INSPECTION REPORT

REPORT NO.	CLIENT P/O NO.	DATE OF REPORT	TOTAL PAGES
TTI20150728_****	20150502	28 th July. 2015	8

CLIENT	*****	VENDOR	*****
INSPECTOR	Kevin	INSPECTION DAYS	4days
VALVE TYPE	API-6A Gate valves	QTY	10pcs
TYPE OF INSPECTION	1- Inspection Qty of order; 2- Visual check 3- Dimensional check 4- Pressure test; 5- Drift test; 6- Drift dimensional check; 7- Documents review;

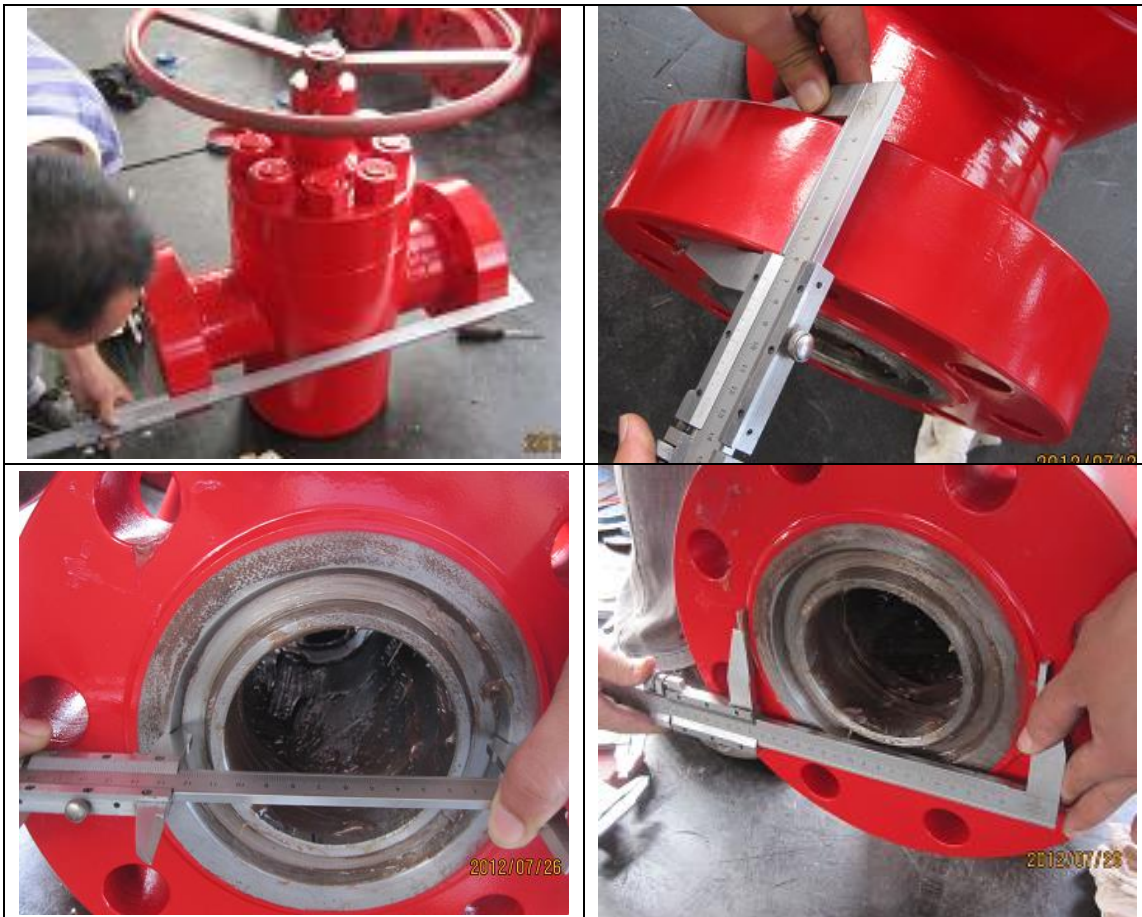
Findings:

1. All marking is blurry after painting

2. All valves stud and nut material is B7/2H, but the drawing is L7M/2HM

3. The bore of valve is rusty

4. All slab valve's hand wheel has no "open" and "close" direction mark

Note: 1. Although the stud and nut material is not according drawing, but it comply API 6A DD requirement. Please you comment!

2. The factory promise to modify the other problems except finding 2.

1. Take off bore rusty
2. All API 6A marking need stamp again, it must be seen clearly after painting.
3. Add "open" and "close" direction marking on hand wheel
4. Rework painting
5. MTR need finish before shipping

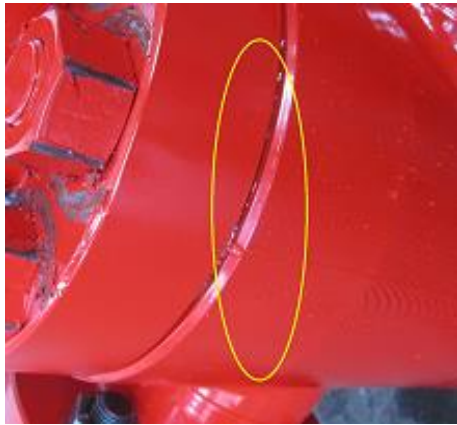
3-1/8"5000psi seat leakage

7-1/16"3000psi seat testing leakage

4-1/16"5000psi shell testing leakage

Note: 1. About seat leakage valves, after lapping wedge and seat again, it passed the testing.

2. About shell leakage valves, after replace a new gasket, it passed the testing.

After repair, it is ok!

After repair, it is ok!

After repair, it is ok!
